**BRUNSWICK STEAM ELECTRIC PLANT, UNIT NOS. 1 AND 2
DOCKET NOS. 50-325 AND 50-324/LICENSE NOS. DPR-71 AND DPR-62
REVISIONS TO PLANT EMERGENCY PROCEDURES**

List of Revised Plant Emergency Procedures

Summary of Revisions

***RADIOLOGICAL EMERGENCY RESPONSE PLAN
(ERP)***

**BRUNSWICK SITE
PLUME EXPOSURE PATHWAY
10 Mile Emergency Planning Zone**
Figure 1.1-6 Population Totals

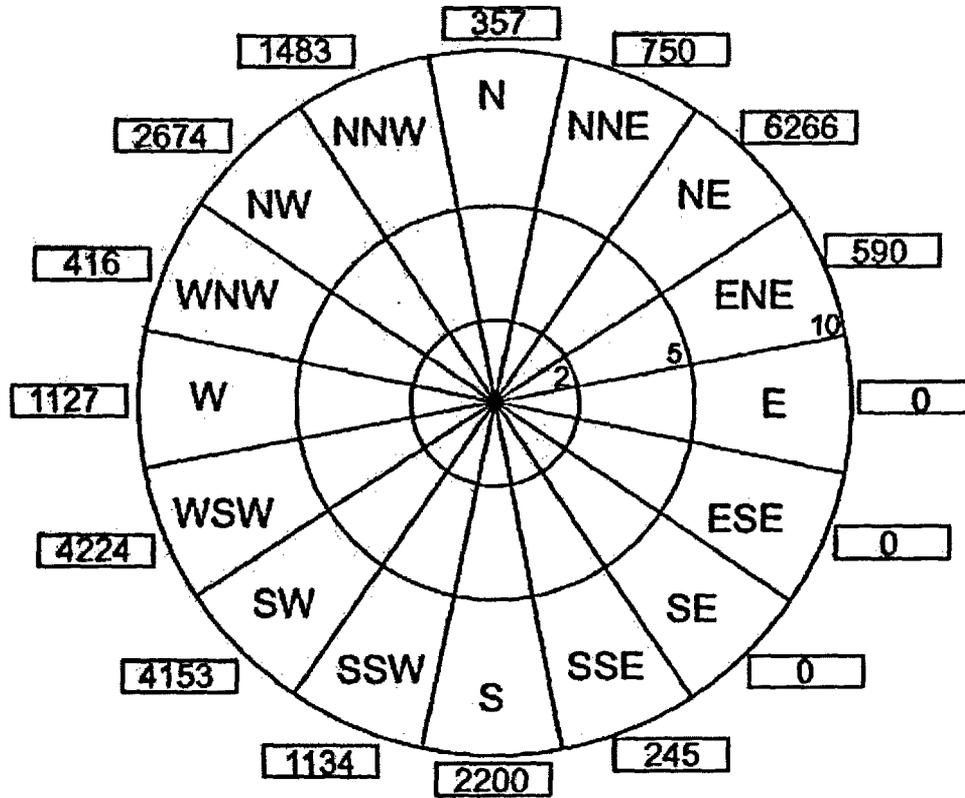
- 7. Revised Section 4.4.6; Figure 1.1-6, Population Totals; Figure 4.4-1, Evacuation Schedule and Warning; and Figure 4.4-2, Evacuation Times, to reflect revised evacuation time estimates for 10-Mile Emergency Planning Zone (EPZ).**

- Revised Section 4.4.6, Figure 1.1-6, Population Totals, Figure 4.4-1, Evacuation Schedule and Warning, and Figure 4.4-2, Evacuation Times to reflect revised evacuation time estimates for 10-Mile Emergency Planning Zone (EPZ).

Figure 3.2-1 Brunswick Emergency Organization

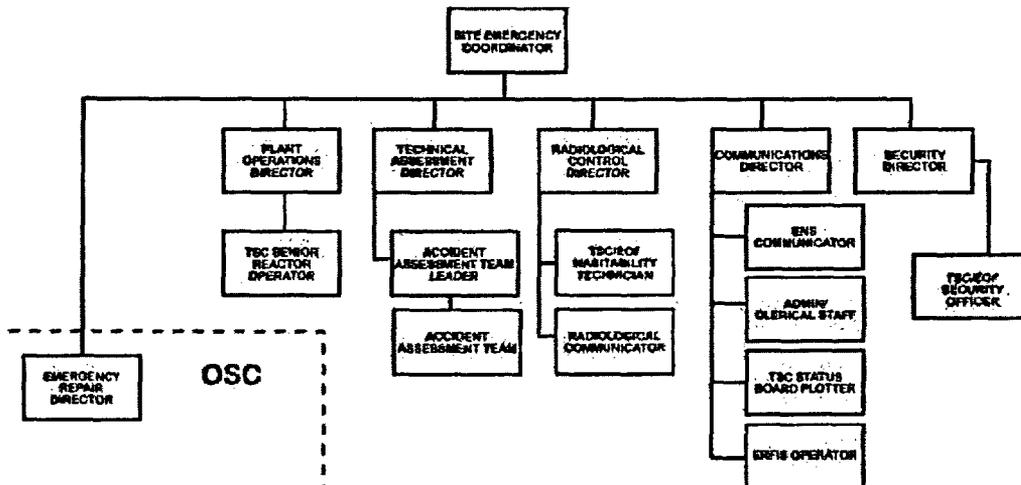
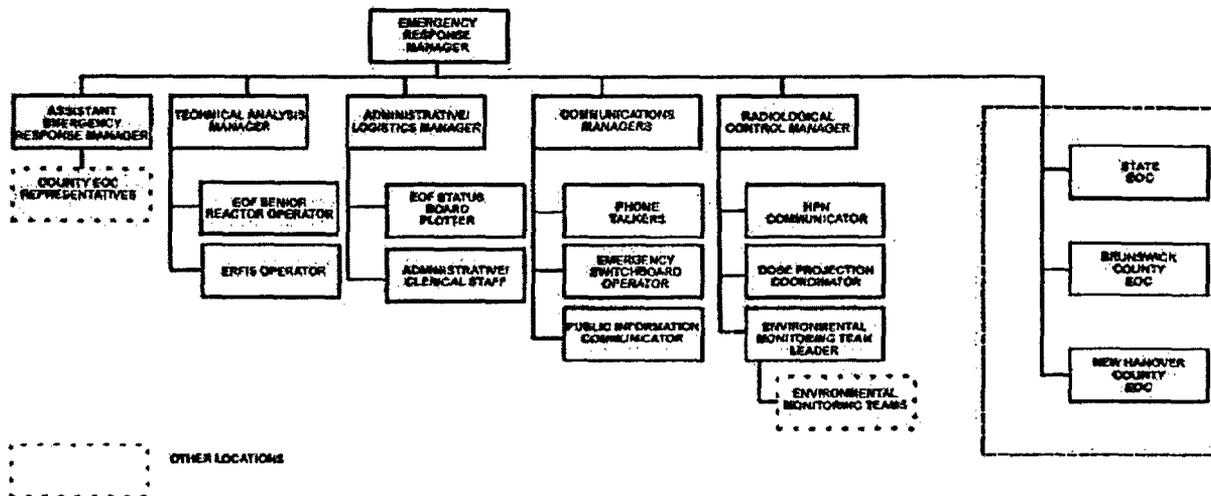
- 3. Deleted “EOF Habitability Technician” and changed “TSC Habitability Technician” to “TSC/EOF Habitability Technician” in Figure 3.2-1, Brunswick Emergency Organization, to reflect the deletion of the EOF Habitability Technician and need for only one individual for habitability surveys, due to co-location of Technical Support Center and EOF.**

- Deleted "EOF Habitability Technician" and changed "TSC Habitability Technician" to "TSC/EOF Habitability Technician" in Figure 3.2-1, Brunswick Emergency Organization, to reflect the deletion of the EOF Habitability Technician and need for only one individual for habitability surveys, due to co-location of TSC and EOF.
